File No. 161051

1 [Amending Ordinance No. 1061 - Sidewalk Width Change - Portion of 30th Avenue Between
2 Clement Street and Geary Boulevard]

DPW Order No: 185327

OFFICIAL SIDEWALK CHANGE ALONG THE EASTERLY SIDE OF 30TH AVE.,
 BETWEEN CLEMENT ST. AND GEARY BLVD., FRONTING AB 1461 LOT 001

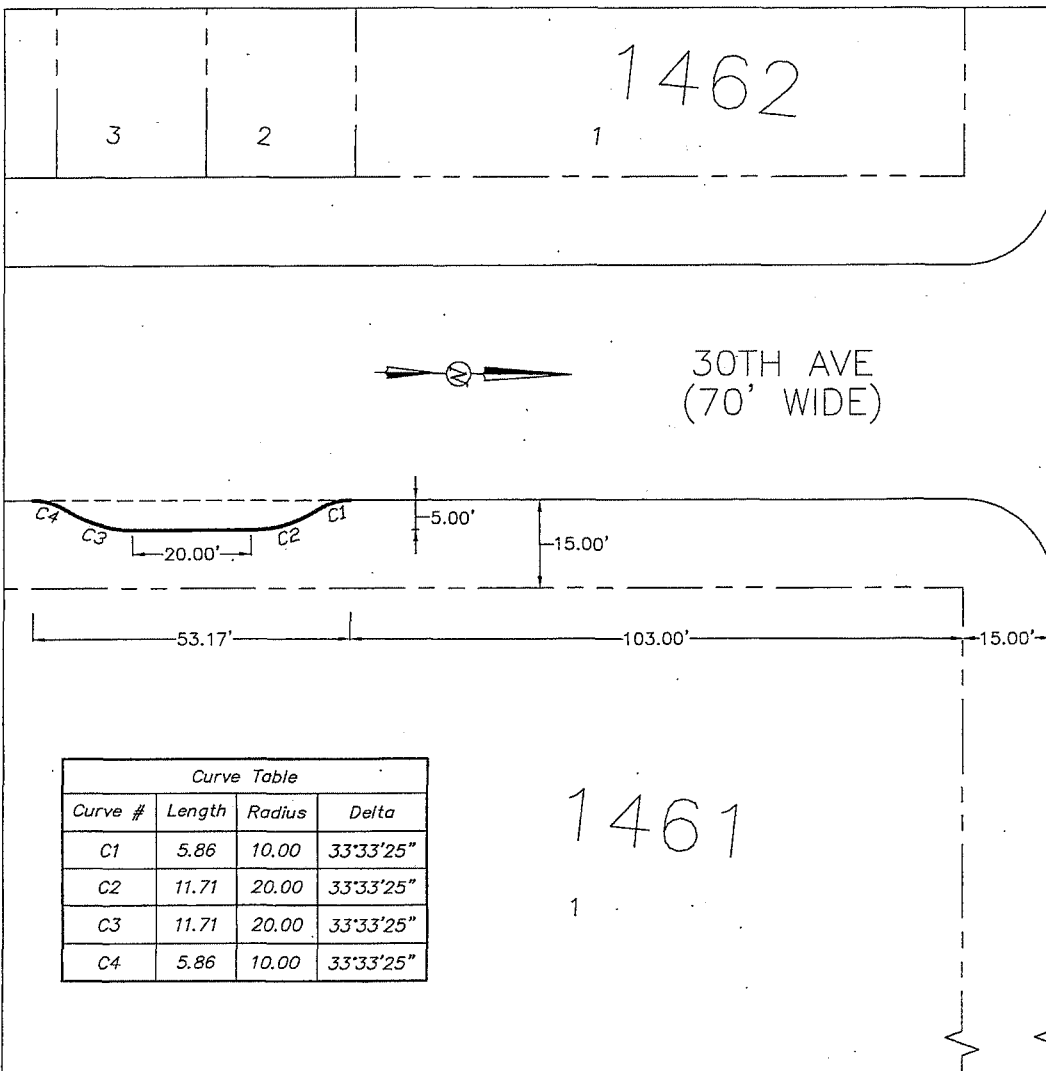
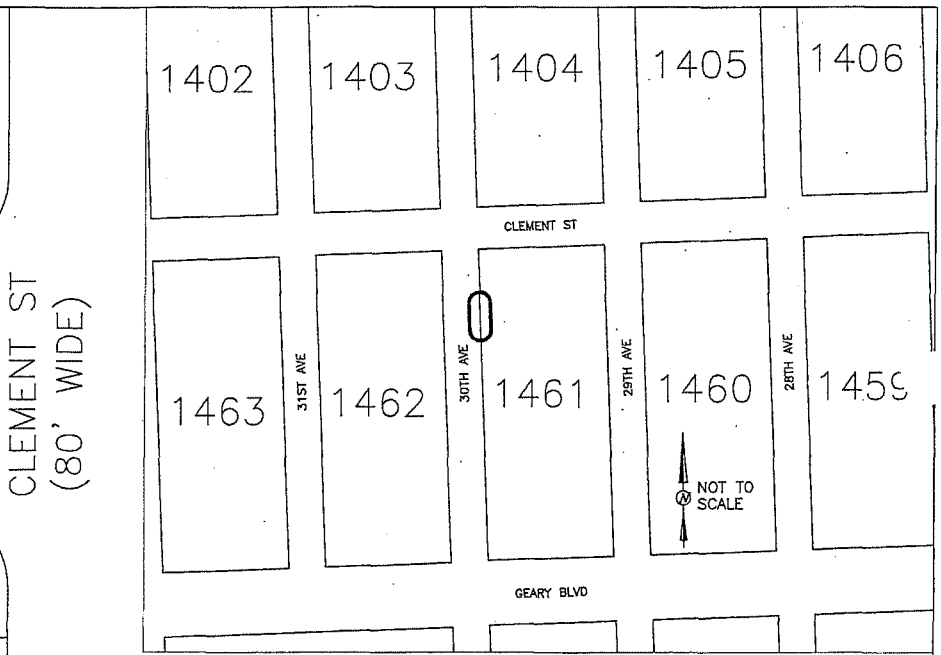
1 sidewalk reduction shall start 103 feet from the northwesterly corner of AB 1461 Lot 001 and continue
2 south for approximately 53 feet, and shall decrease the sidewalk width by 5 feet, from a width of 15 feet
3 to 10 feet, as shown on Department of Public Works drawing Q-20-867, a copy of which is in the Clerk
4 of the Board of Supervisors File No. 161051

The proposed plan is to create an ADA compliant handicapped drop-off zone at the front entry of the school as a Part of the Presidio Middle School's (430 30th Avenue) general modernization. The drop off zone is proposed along 30th Avenue fronting the school ramp access. The bulb-in will reduce the existing sidewalk width 5 feet, from the existing 15 feet to 10 feet. The complete length of the proposed bulb-in is approximately 53 feet. The start of curve is 103 feet from the northwesterly corner of AB 1461 Lot 001. This project will promote pedestrian safety and comfort, and enhance the urban design of 30th Avenue.
